World Forum for Harmonization of Vehicle Regulations (WP.29)

Working Party on Lighting and Light-Signalling (GRE)

PROPOSAL FOR DRAFT AMENDMENTS TO REGULATION No. 37

(Filament lamps)

**"CATEGORIES P24W, PX24W, PY24W, PR24W, PS24W, PSX24W, PSY24W and PSR24W**

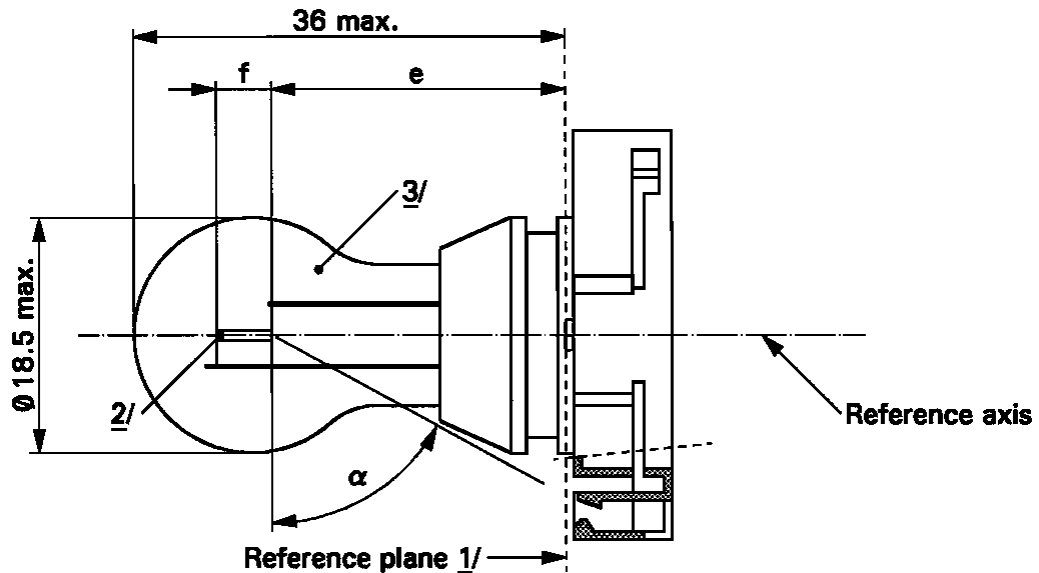
Sheets from P24W/1 to P24W/3, amend to read: (see next pages)

- 1/ The reference plane is defined by the meeting points of the cap-holder fit.
- 2/ No actual filament diameter restrictions apply but the objective is  $d$  max. = 1.1 mm.
- 3/ The light emitted from normal production lamps shall be white for categories P24W, **PX24W**, PS24W and **PSX24W**; amber for categories PY24W and PSY24W; red for the categories PR24W and PSR24W. (See also note 8/)

**CATEGORIES P24W, PX24W, PY24W, PR24W, PS24W, PSX24W, PSY24W and PSR24W**

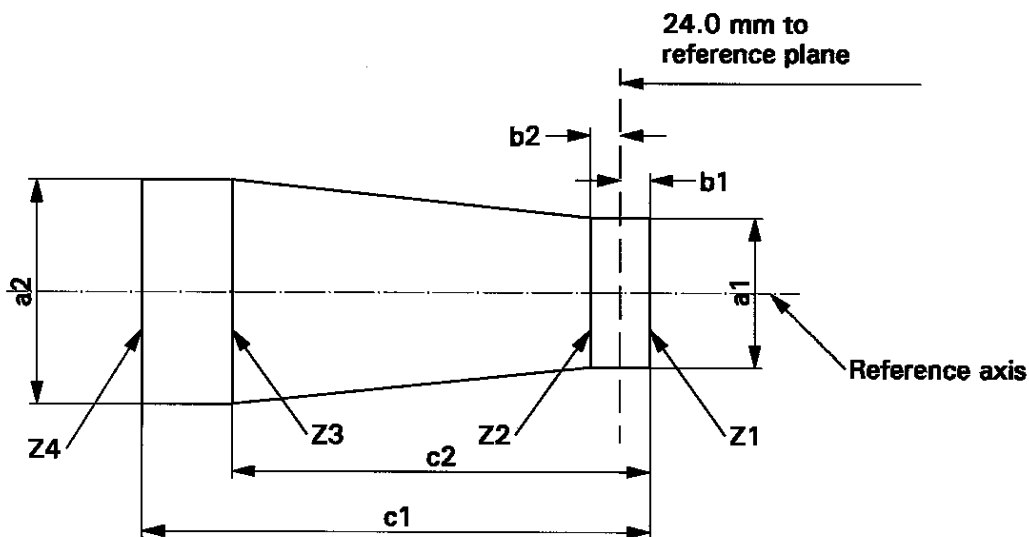
| Dimensions in mm   |                       | Filament lamps of normal production                         |                               |   | Standard filament lamp |  |
|--|-----------------------|---|-------------------------------|---|------------------------|--|
| f  | <u>5/</u> , <u>6/</u> | <b>P24W, PY24W, PR24W, PS24W, PSY24W, PSR24W</b>            | 4.0                           |   | <b>4.0</b>             |  |
|  |                       | <b>PX24W, PSX24W</b>  | <b>4.2</b>                    |   | <b>4.2</b>             |  |
| $\alpha$   |                       | <u>7/</u>   | <b>58.0°</b>                  |   | <b>58.0° min.</b>      |  |
|  |                       |   | <b>PX24W</b><br><b>PSX24W</b> | 500 +10/- <b>15</b> %                         |                        |  |
| Reference luminous flux at approximately   |                       |   | <b>12 V</b>                   | <b>White: 345 lm</b>                          |                        |  |

- 4/ For categories PS24W, **PSX24W**, PSY24W and PSR24W, dimensions shall be checked with O-ring removed.
- 5/ The filament position is checked by means of a "box-system"; sheet P24W/3.
- 6/ The ends of the filament are defined as the points where, when the viewing direction is perpendicular to the plane through the filament lead-in wires as shown in the drawing on sheet P24W/1, the projection of the outside of the end turns crosses the filament axis.
- 7/ No part of the cap beyond the reference plane shall interfere with angle  $\alpha$ . The bulb shall be optically distortion free within the angle  $2\alpha + 180^\circ$ .
- 8/ The light emitted from standard filament lamps shall be white for categories P24W, **PX24W**, PS24W and **PSX24W**; white or amber for categories PY24W and PSY24W; white or red for categories PR24W and PSR24W.
